A-6-LJS-20-0008 (Abbott Residence)

CORRESPONDENCE

Re: Appellants' Response to Staff Report Dated November 3, 2021 Concerning Appeal Number A-6-LJS-20-0008 Which Recommends Approval of Abbott Coastal Development Permit with Conditions

**RE: Review of Revised Preliminary Drainage Study Dated 4/26/2021 for the
“Abbott Residence”**

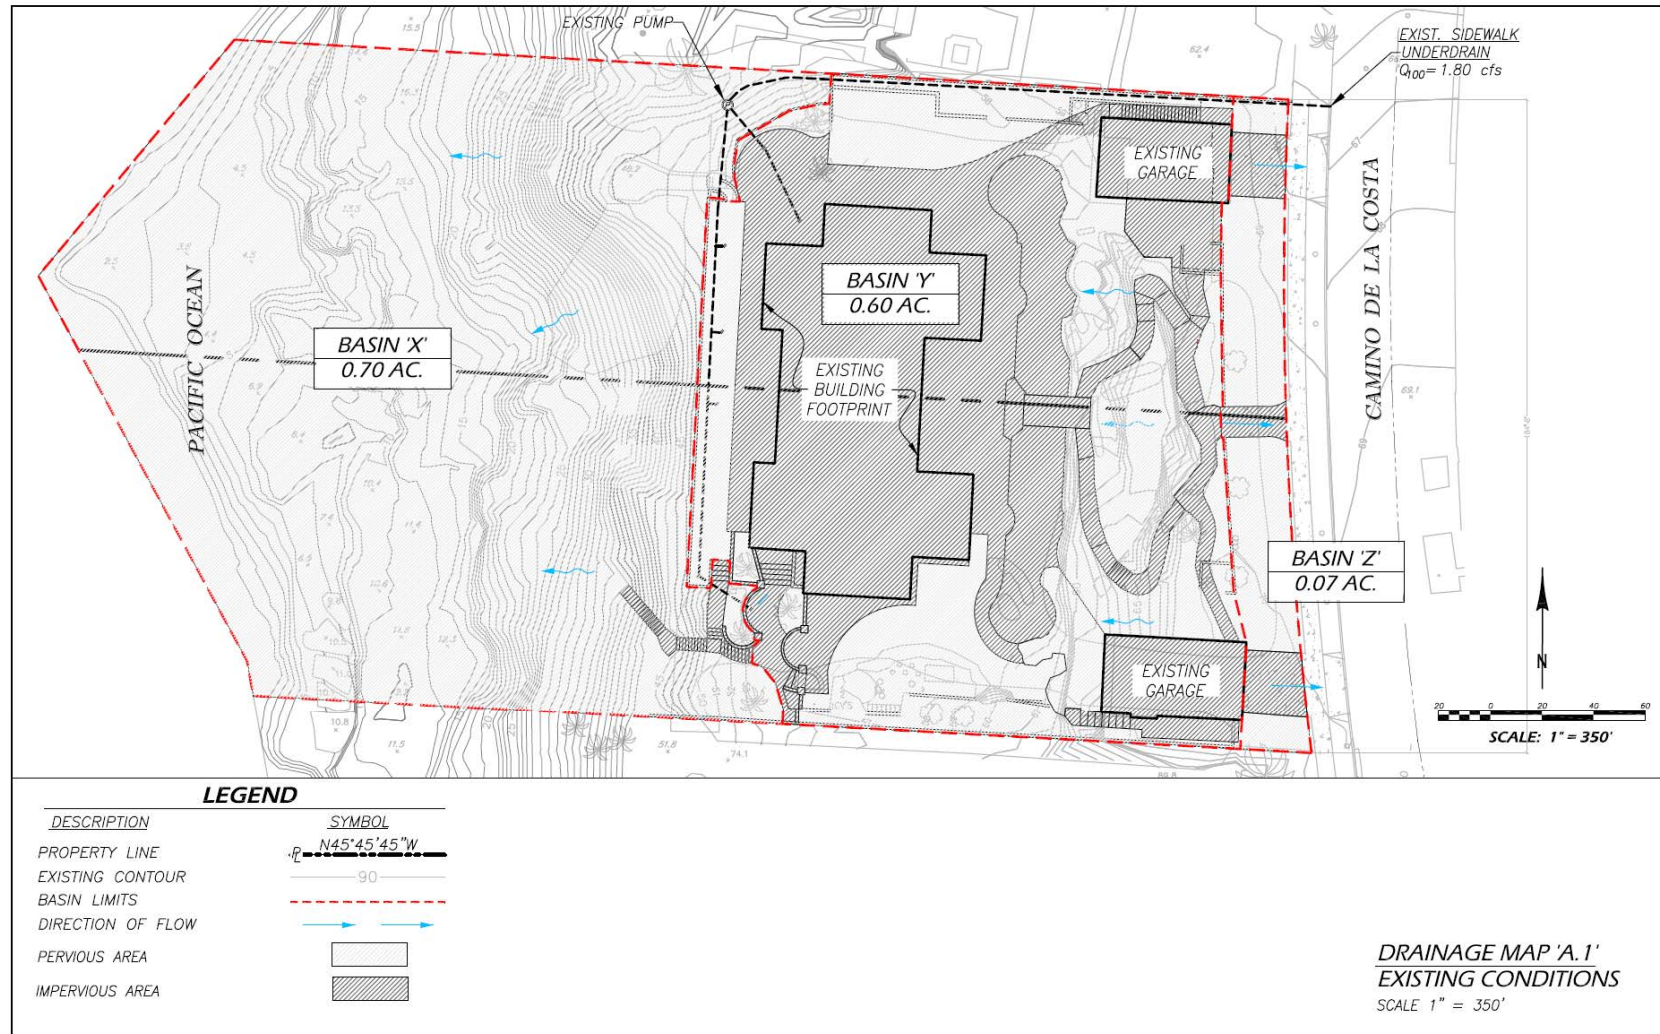
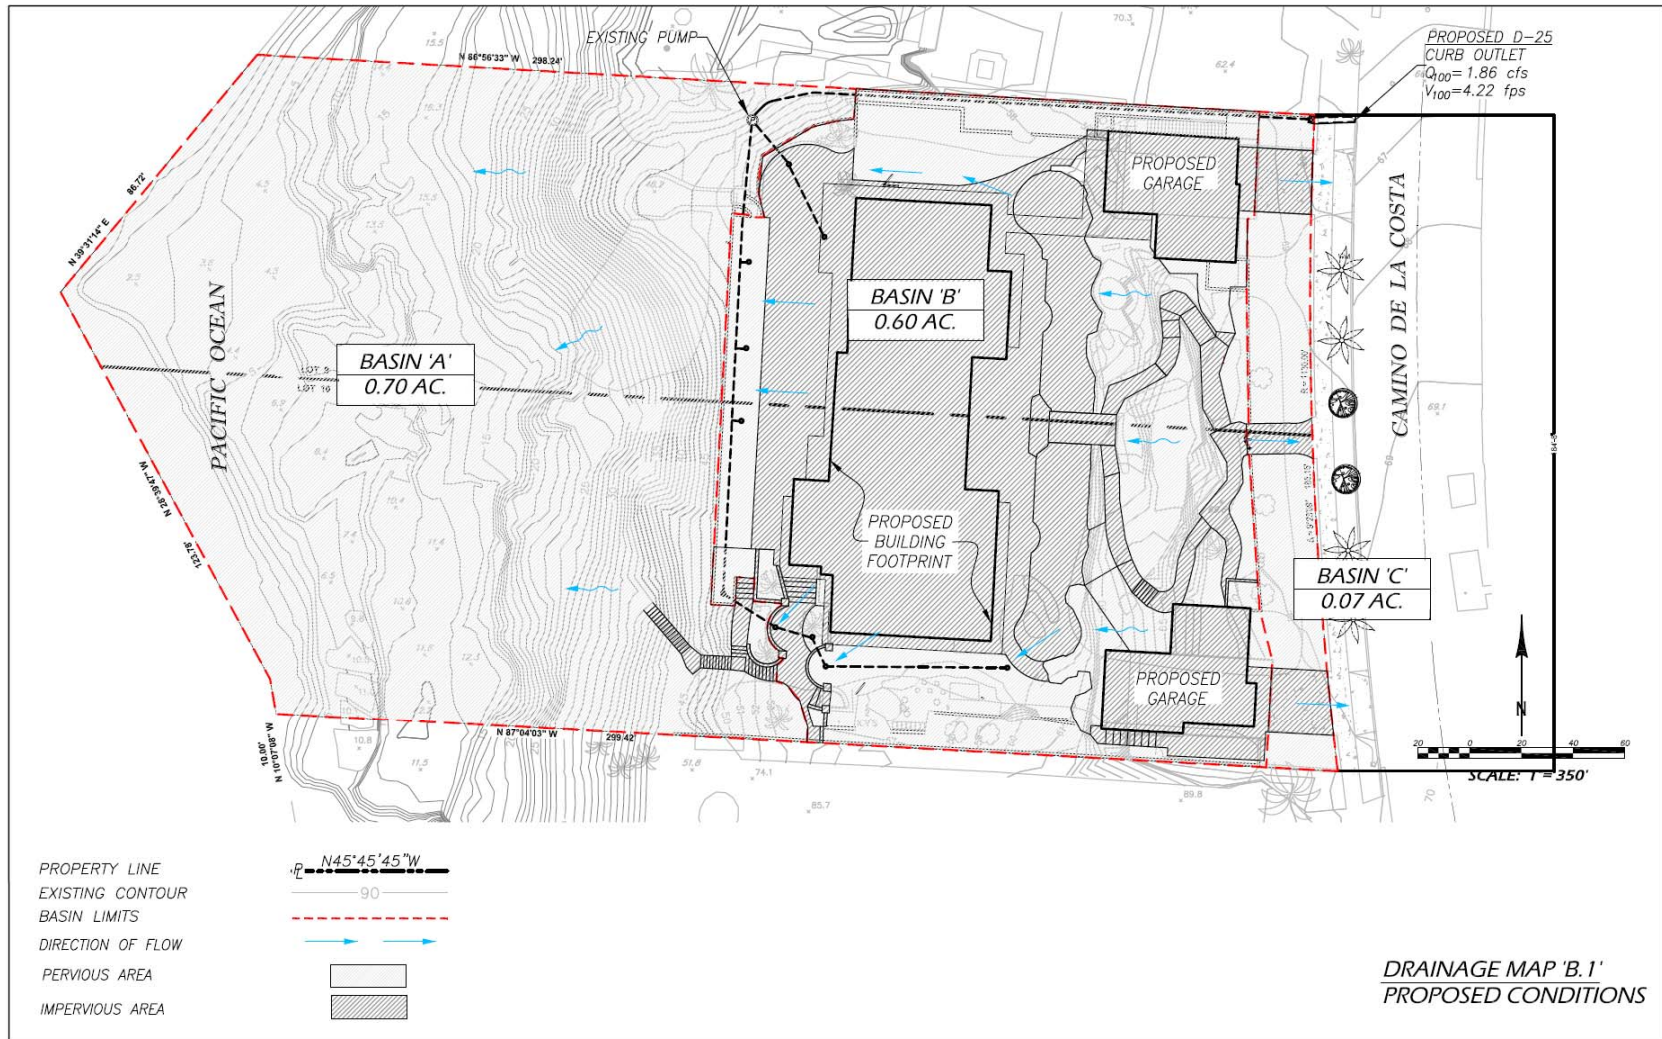
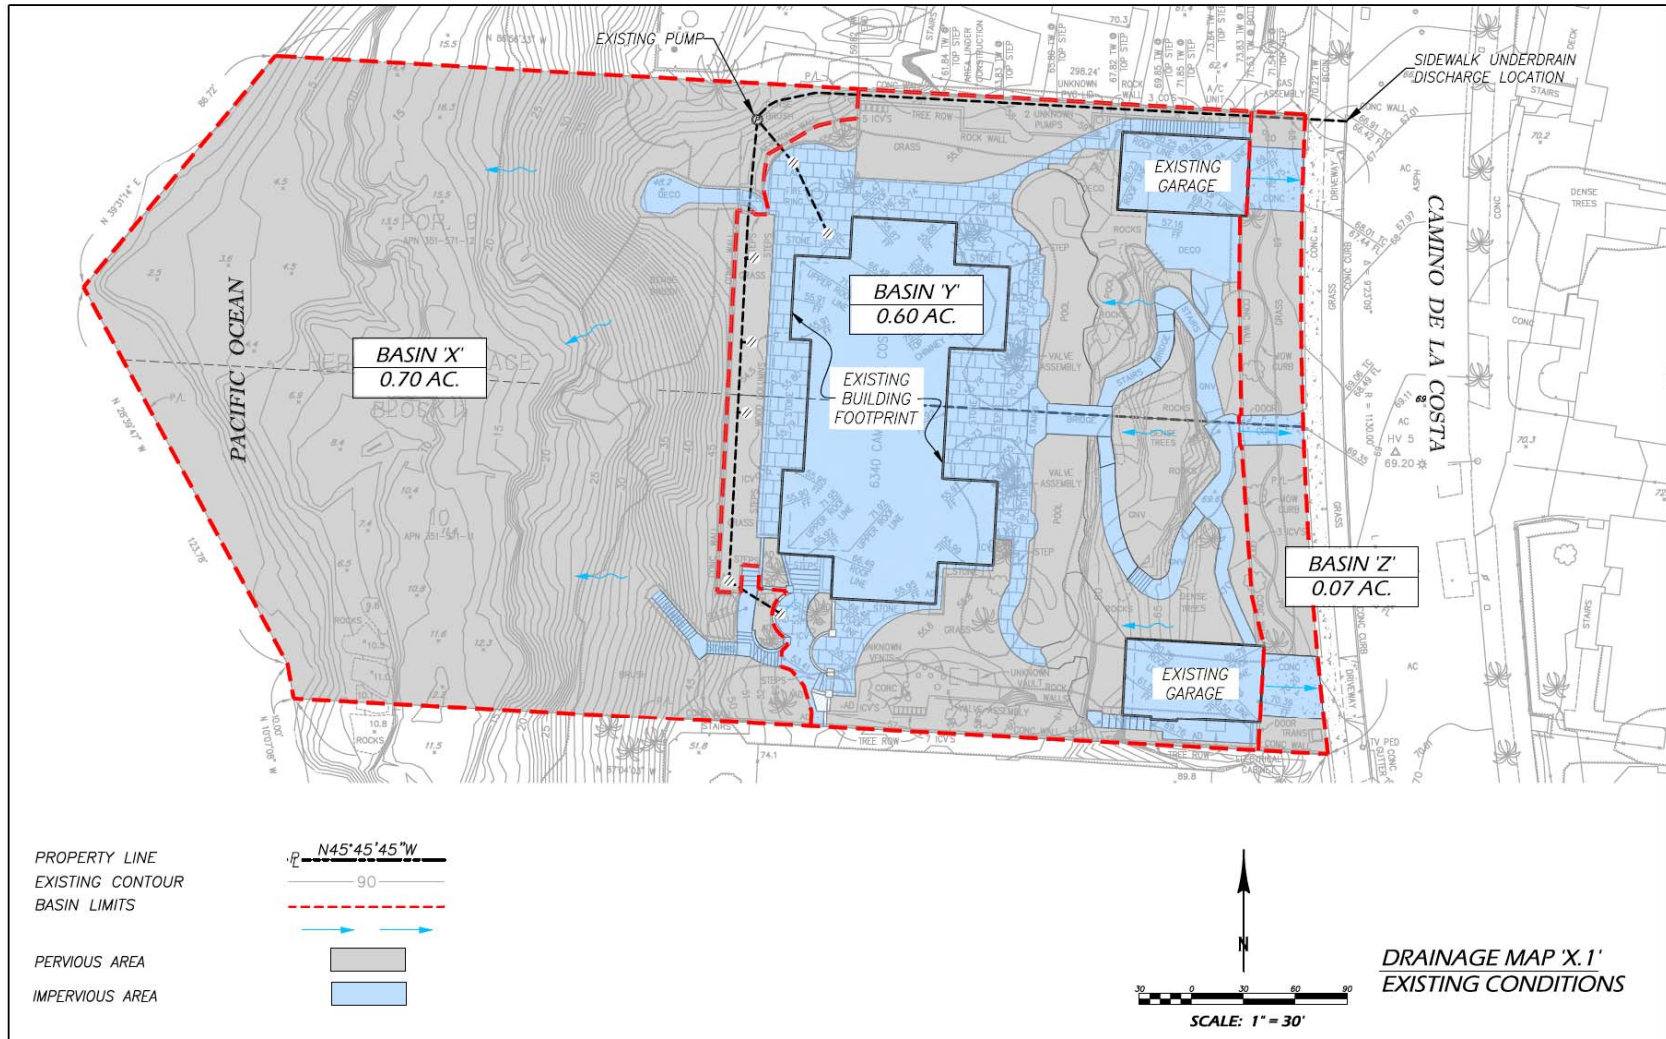
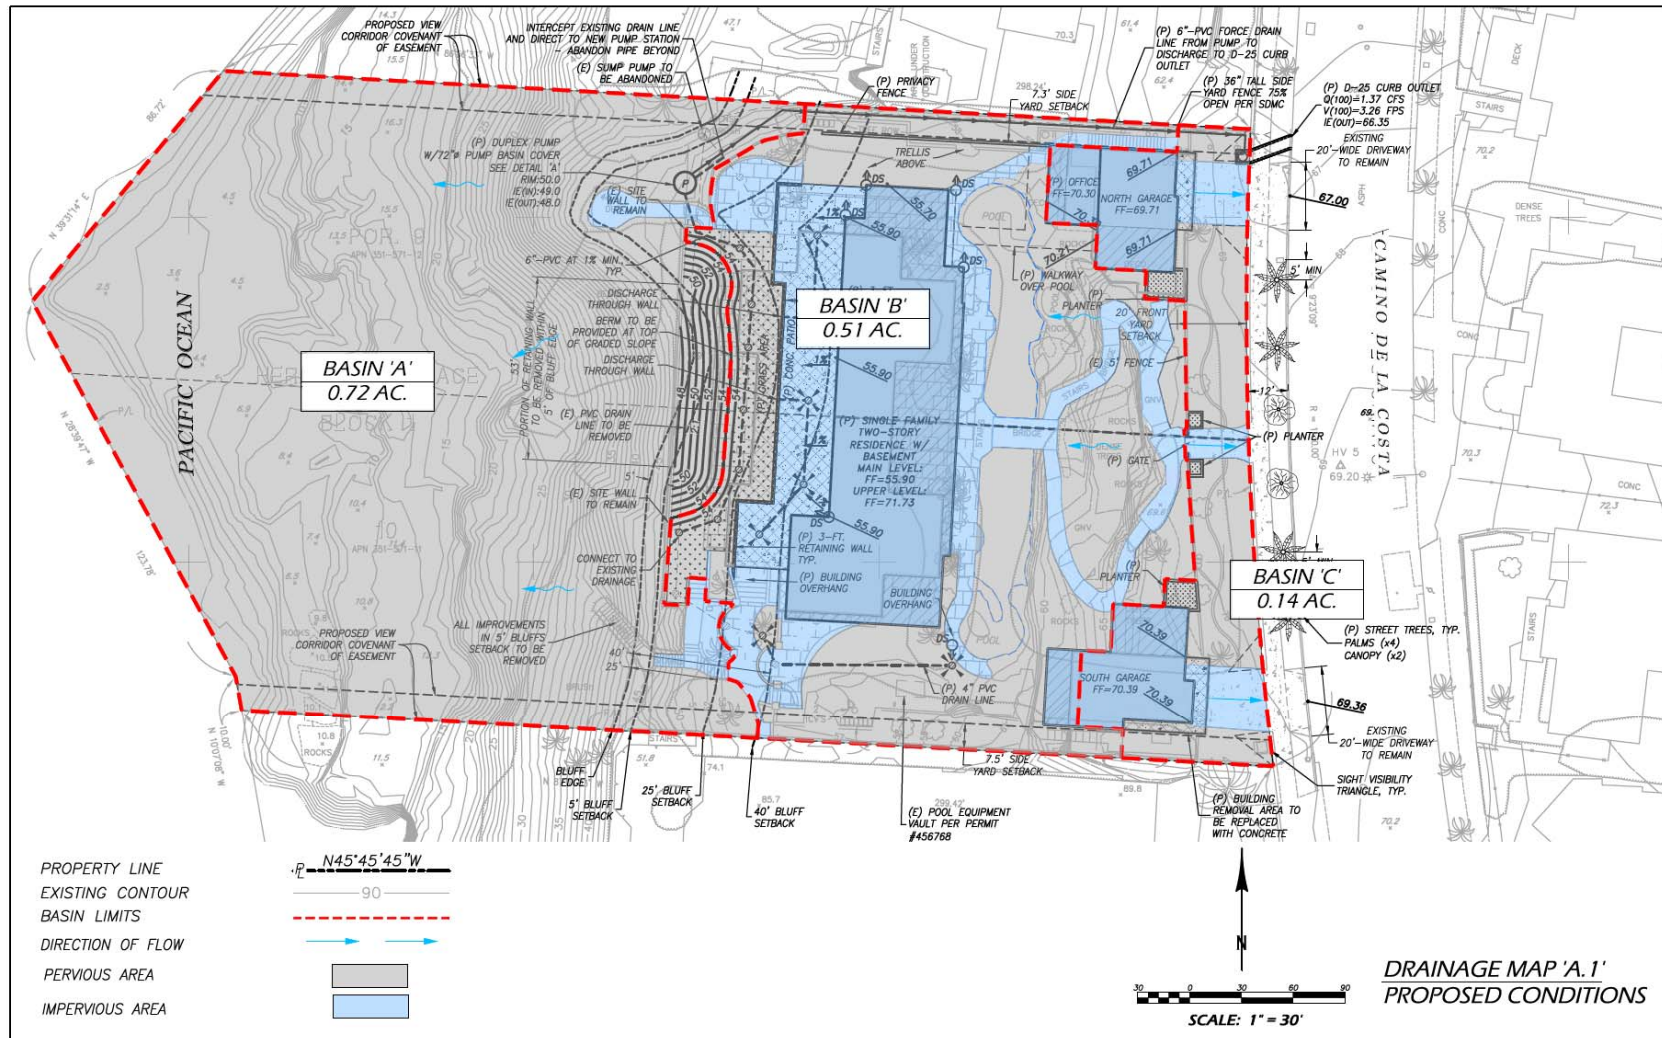
Further, a number of assumptions have changed from the previous drainage study in the Revised Drainage Study without explanation, which have the potential to significantly affect the underlying calculations. Of particular note, in the previous drainage study the swimming pool was calculated as impervious, but in the Revised Drainage Study the swimming pool is calculated as pervious. As such, additional water entering the pool during a storm event would necessarily create runoff, which is likely to be exacerbated with the additional impervious roof area added by the proposed Project design. Moreover, assumptions as to the pre-construction conditions reflecting impervious and pervious numbers, as well as the drainage for Basin Y on the pre-construction charts, have been modified between the two plans. Given that the underlying pre-construction conditions could not have changed between these two drainage studies, we are skeptical of the resulting calculations derived from these inputs. Namely, if you allocate the pool alone as impervious (as the previous study did), it appears the project design will increase rather than decrease storm water runoff. True and correct copies of the relevant drainage study diagrams illustrating the change in the pool from impervious to pervious are enclosed along with this letter.

A number of assumptions have changed from the previous drainage study in the Revised Drainage Study without explanation, which have the potential to significantly affect the underlying calculations. Of particular note, in the previous drainage study the swimming pool was calculated as impervious, but in the Revised Drainage Study the swimming pool is calculated as pervious. This does not make sense because the pool uses an infinity edge design with impervious stone around and is a “closed” system. As such, additional water entering the pool during a storm event would necessarily create runoff, which is likely to be exacerbated with the additional impervious roof area added by the proposed Project design. Moreover, assumptions as to the pre-construction conditions reflecting impervious and pervious numbers, as well as the drainage for Basin Y on the pre-construction charts, have been modified between the two plans. Given that the underlying pre-construction conditions could not have changed between these two drainage studies, we are skeptical of the resulting calculations derived from these inputs. Namely, if you allocate the pool alone as impervious (as the previous study did), it appears the project design will increase rather than decrease storm water runoff.
